## **The Corporation of the Town of Tecumseh**

### **Planning Report**

**Subject:** **Minor Variance Applications A-22-21 to A-26-21**

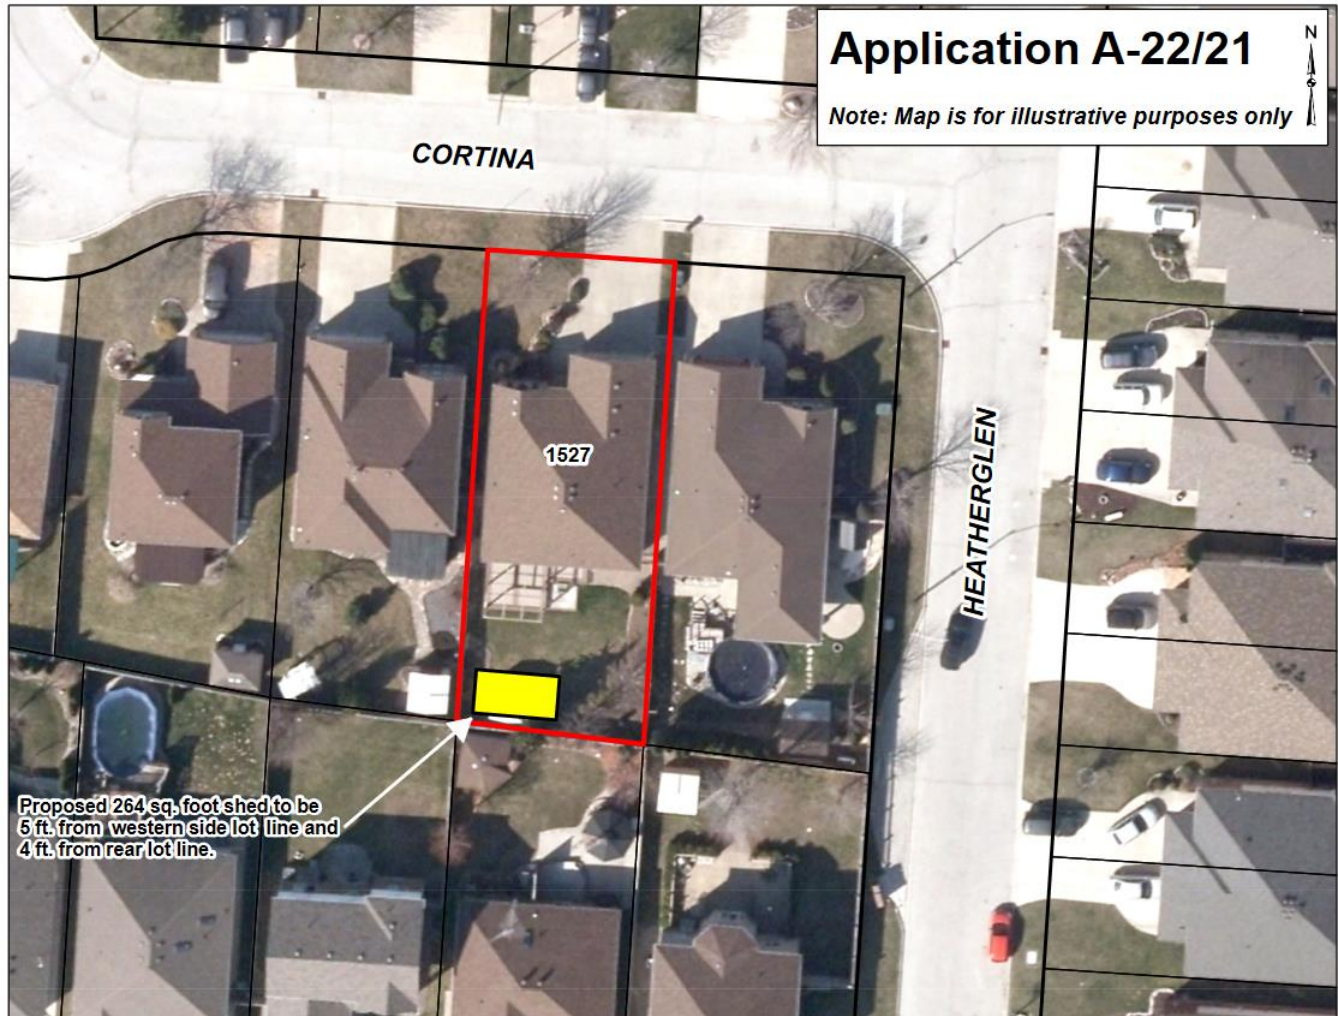
The purpose of the Application is to request relief from subsection 7.1.5 which establishes a maximum lot coverage of 30 percent. The Applicant is proposing to construct a 24.5 square metre (264 square foot) accessory shed resulting in 34 percent lot coverage (see sketch below).

The purpose of the 30 percent maximum total lot coverage is to ensure that the scale and massing of buildings are appropriate and that the lot will be able to provide adequate areas for landscaping, parking and other amenities. The proposed lot coverage of 34 percent will not result in any deficiencies in landscaping requirements or the ability of the site to provide for parking or open space areas. All other requirements of the R2-20 zone will be complied with.

No undue adverse impact is anticipated as a result of the proposed construction of the accessory structure. Any impact the shed and resulting total lot coverage may have is mitigated as a result of its location adjacent the accessory structures on the lots to the west and south as well as the buffering effect of the existing landscaping along the rear lot line. It is therefore my opinion that the requested relief is minor in nature.

- As part of the building permit process, the owner will be required to provide details on how runoff from the proposed addition will be controlled to prevent it from flowing onto neighbouring properties to the satisfaction of the Chief Building Official.

<b>Application:</b>	<b>Minor Variance Application A-24-21</b>
<b>Applicant:</b>	<b>Marc Tourangeau</b>
<b>Location of Property:</b>	<b>844 Lesperance Road</b>

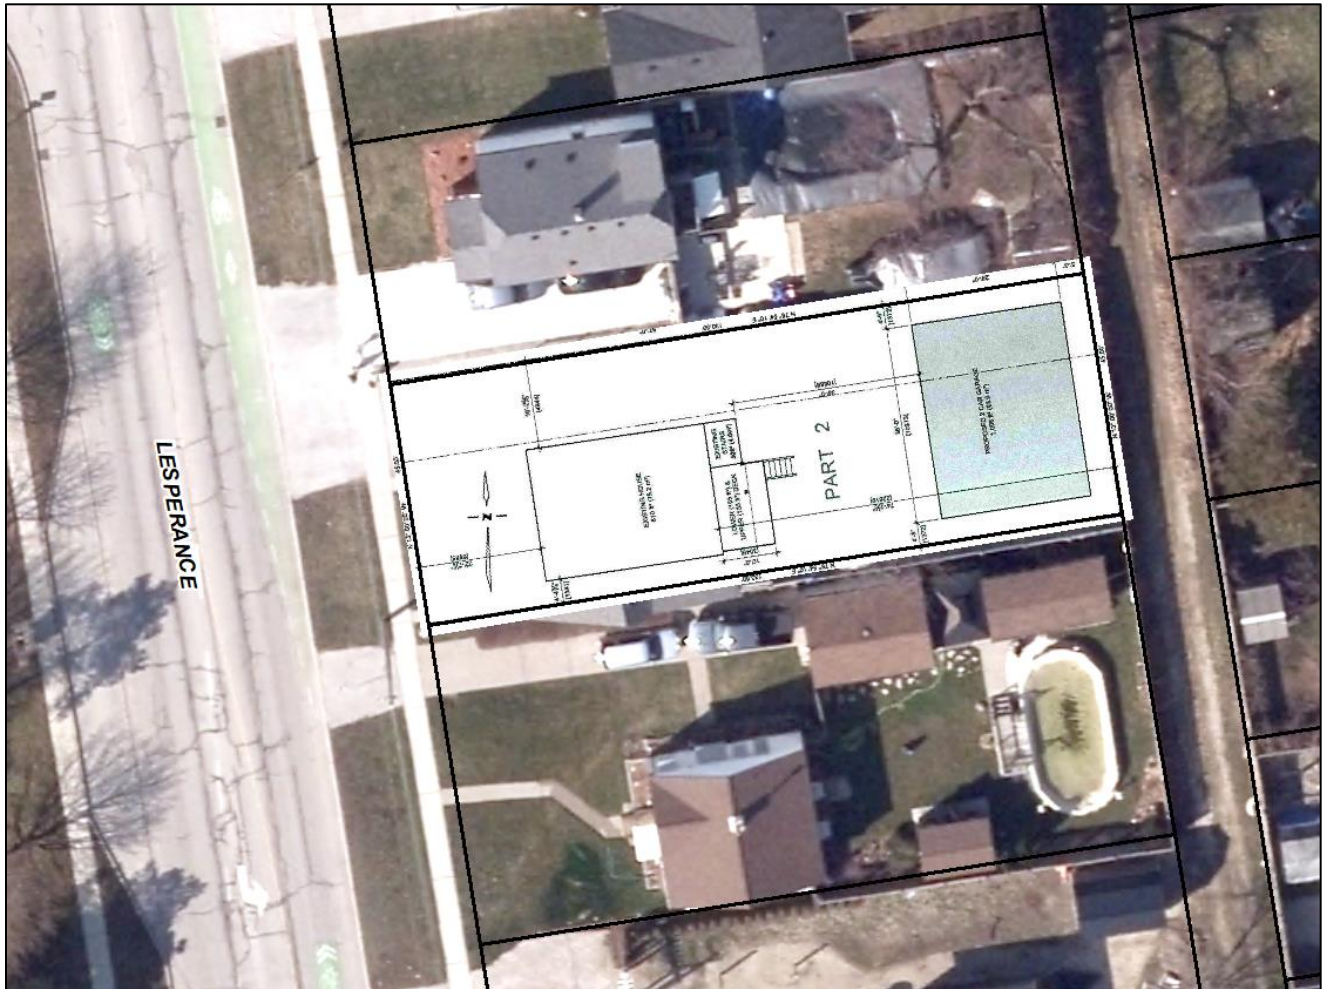
The Applicant is requesting relief to construct a 93.6 square metre (1,008 square foot) accessory building resulting in 35 percent lot coverage.

The purpose of the 30 percent maximum total lot coverage is to ensure that the scale and massing of buildings are appropriate and that the lot will be able to provide adequate areas for landscaping, parking and other amenities. Given that the proposed structure occupies a large majority of the rear yard, the ability to provide adequate landscaping and amenity areas is undermined. In fact, it appears that if the proposed accessory structure were to be allowed, the resulting landscaped open space would be approximately 28 percent which is under the minimum of 30 percent established in the By-law. Further, in order to provide access to the southerly garage door, additional landscaped opens space would need to be eliminated.

It is therefore my opinion that a 93.6 square metre (1,008 square foot) accessory structure resulting in 17.2 percent lot coverage fails to meet this test with respect to the foregoing provisions.

Given the massing of the proposed structure combined with the relatively small lot size and the resulting deficiency in landscaped open space and the extent of the proposed relief, it is my opinion that the requested relief is not minor in nature.

In order to prevent storm water runoff from adversely affecting the abutting property, a satisfactory grading and drainage plan from a qualified person will be required before the issuance of a permit, in accordance with the Town's Grading, Filling, Dumping and Topsoil Removal By-law.

**Application: Minor Variance Application A-25-21**  
**Applicant: Warren Fullerton and Linda Simetic**  
**Location of Property: 157 Rutland Road**

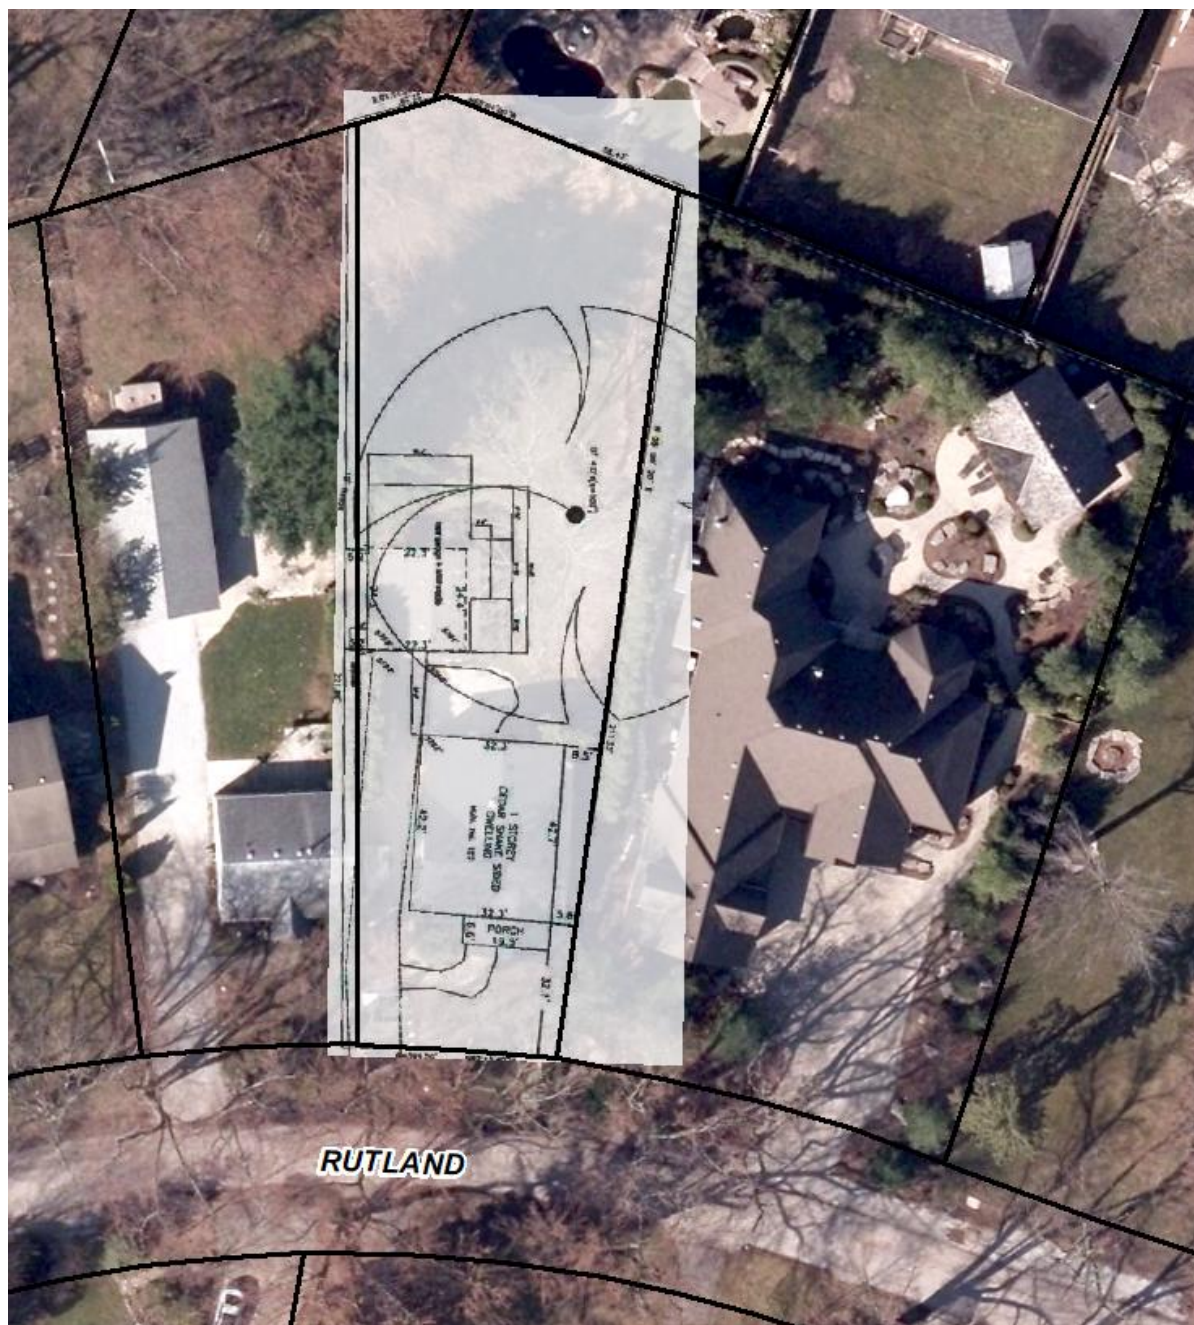
The Applicants were originally requesting relief to construct a 92.3 square metre (993 square foot) two-storey accessory building having a height of 5.9 metres (19.25 feet). Subsequent the submission of the application and, as a result of discussions with the Essex Region Conservation Authority, the Applicants revised their proposal by reducing the height of the accessory building to 3.94 metres (12.92 feet) thereby eliminating the need for relief from the aforementioned maximum height provision of the Zoning By-law.

The purpose of the 70 square metre (753 square foot) area maximum size for an individual accessory building or structure is to ensure the accessory structure remains normally incidental, subordinate and exclusively devoted to the main residential use and that the presence of accessory buildings and structures do not undermine the intended residential character of the property. It should be noted that the proposed accessory structure equates to 7.1 percent lot coverage and, when combined with the existing 434.3 square metre (1,425 square foot) dwelling, the total lot coverage is 17.3 percent. Provided that the Committee is satisfied that the structure is designed and intended for the owners' personal use, it is my opinion that the proposed variance meets the intent of this provision of the By-law.

- No comments with regard to the requested minor variance, however, the issue of ingress and egress to this site during times of flooding should be reviewed with the Tecumseh Fire Department and the Essex Region Conservation Authority.

- The above noted lands are subject to our Development, Interference with Wetlands and Alteration to Shorelines and Watercourses Regulation under the Conservation Authorities Act (Ontario Regulation No. 158/06). The parcel falls within the regulated area of the Lake St. Clair. The property owner will be required to obtain a Permit from the Essex Region Conservation Authority prior to any construction or site alteration or other activities affected by Section 28 of the Conservation Authorities Act.

In order to prevent storm water runoff from adversely affecting the abutting property, a satisfactory grading and drainage plan from a qualified person will be required before the issuance of a permit, in accordance with the Town's Grading, Filling, Dumping and Topsoil Removal By-law.

**Applicant:** Kaitlin McCarrell  
**Location of Property:** 837 St. Pierre Street

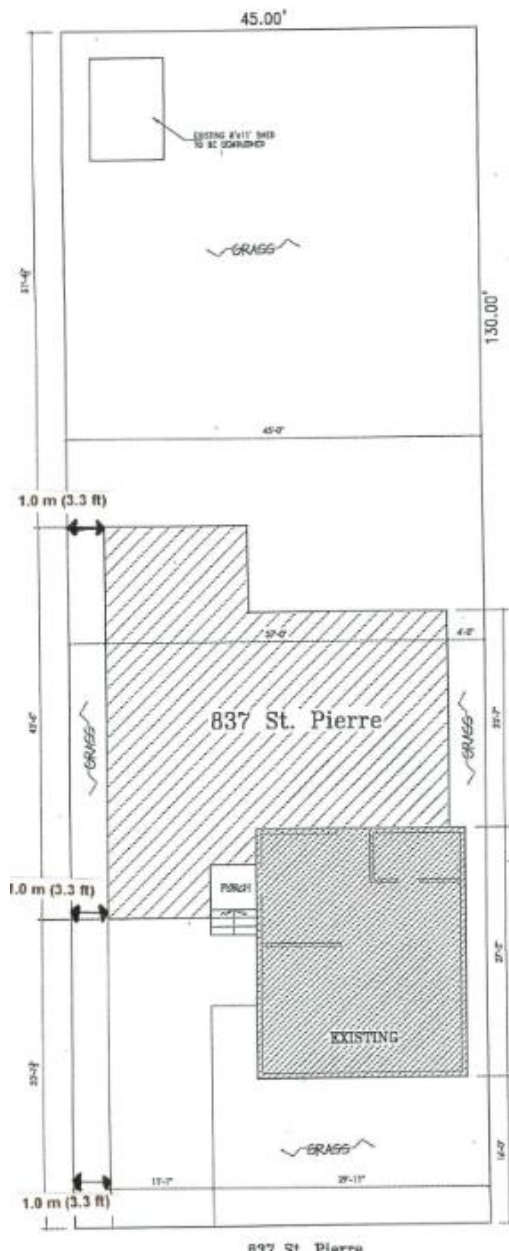
Although not ideal, the proposed 1.0-metre (3.3-foot) side yard is adequate for access to the rear yard. Further, exterior maintenance should not be problematic because the proposed addition is single storey and its westerly wall contains no openings. It should also be noted that the Building Code will require restrictions on openings (i.e. no windows) and the type of building material to address fire protection. Adequate storm water measures will need to be implemented to ensure storm water conveyance is managed such that it will not negatively affect the abutting property owner. Subject to the foregoing being adequately addressed, it is my opinion that the intent of the By-law will be maintained.

- The downspouts should be directly connected to the municipal storm sewer, at the owner's expense, to prevent runoff from the addition onto the adjacent property and that rear yard drainage be installed.
- Since the distance is less than 4 feet the Ontario Building Code will not allow any windows and the interior of the wall is required to have 5/8 type X drywall finish (45 minute fire resistance rating).

- Applicant will need to call in for a Hydro Service/Meter relocation. The existing service is an overhead feed where the service stack/hydro meter are located on the back side of the existing house where the proposed addition is going.

- Concerned with the fire separation from the 6 ft wooden pressure treated fence.
- Concerned with respect to drainage and whether eavestroughs are proposed and where they would direct rainwater.
- Concerned whether there would be an issue with home insurance should something happen.
- Would like to assume responsibility for trimming trees due to the building being so close.
- If all these concerns are addressed, I do not have an issue with the variance.

That the downspouts be directly connected to the municipal storm sewer to prevent runoff from the addition onto the adjacent property and that rear yard drainage be installed to the satisfaction of the Chief Building Official.
